# River network and hydro-geomorphology parametrization for global river routing modelling at 1/12° resolution

Author response to reviewer #2

Amur-Argun-Kherlen River System. The Amur river network is drawn in blue, the Kherlen River in black, while their boundaries are in green and grey, respectively. The orange line represents the basin boundary of the Amur River basin from GRDC.

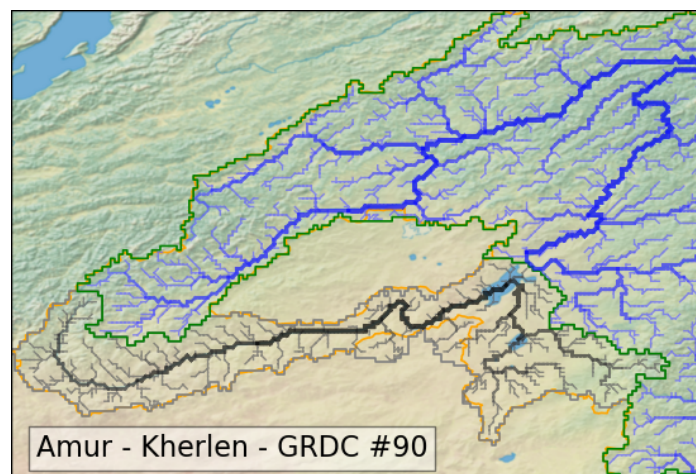
*L203 Fig. 8*

*Probably it is better to explain that how to treat Lake Hulun is the source of the difference. Lake Hulun is usually an inland lake without outlet, but it is connected to the Amur in flooding year. Whether to include Lake Hulun in Amur basin or not highly depends on the developer’s decision.*

The reviewer is right, the main source of the difference between the river networks is the way Lake Hulun is treated. The following sentences have been added at the end of the previous paragraph, and the cause of the differences in Table S1 has been modified accordingly:

“Another noticeable difference can be shown in the upper Amur River basin (Asia) in which the Kherlen River appears disconnected to the Argun River, a tributary of the Amur River, while both are connected at Lake Hulun in the GRDC database. Lake Hulun is usually an inland lake without outlet, but in wet periods it may overflow and then join the Argun River (Brutsart and Sugita, 2008). As for the South Indian Lake, the developer of MERIT-Hydro preferred to keep them separated, which is reflected in the 12D river network.”

Figure 8. Tigris-Euphrates river system.

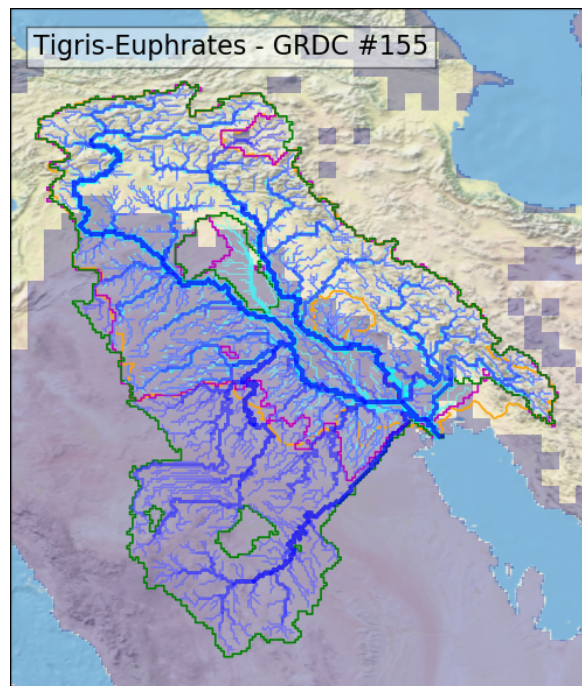
*L204: “This major difference can be neglected since it is within the arid region of the Arabian Peninsula.”*

*This sentence is confusing, I assume the authors are discussing about the Amur basin, but why “Arabian Peninsula” is mentioned?*

Besides, to illustrate the differences between GRDC and the 12D network over arid regions, the example of the Amur River basin has been replaced by the Tigris-Euphrates river system. The text and Fig. 8 with its caption are modified accordingly.

Of course, there was a mistake here. Nevertheless, we now show the example of the Tigris-Euphrates river system, and the portion of the basin which differs between river networks is in the Arabian Peninsula.
